REFERENCE:	Nova Bus Manuals
SECTION:	16: Electrical system
RS N°:	MQR 7621-2619
EFFECTIVE IN PROD.:	LF46 (2023JL)

SUBJECT:	Battery tray
JUSTIFICATION:	Battery tray may crack, new battery hold down required.

#1 Inspection

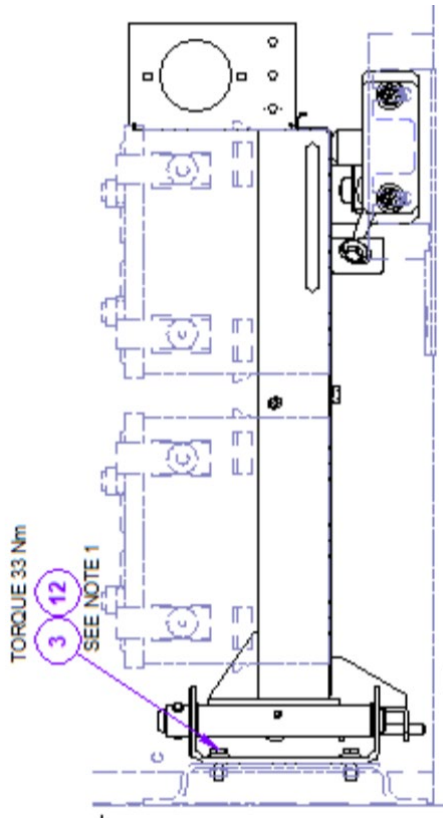
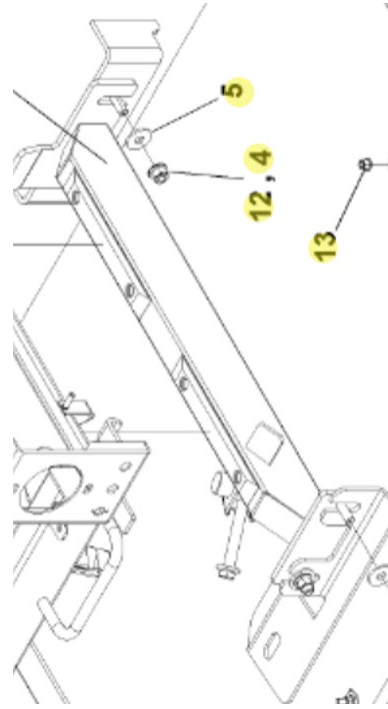
- Inspect bottom of battery tray for cracks
- If cracked, contact Nova rep
- If not cracked, continue procedure

- Add blue Loctite to threads
- Torque all 4 bolts to 33Nm
- Add torque seal to bolt heads

- Ensure support arm is contacting bottom of battery tray
- Adjust, if necessary
- Torque bolts to 33Nm
- Add torque seal to nuts

**Ensure support arm is contacting
bottom of battery tray**

- Remove existing hold downs
- Inspect battery cables and posts for damage
- Replace if damaged

- Install new hold downs
- Torque to 7Nm
- Add torque seal
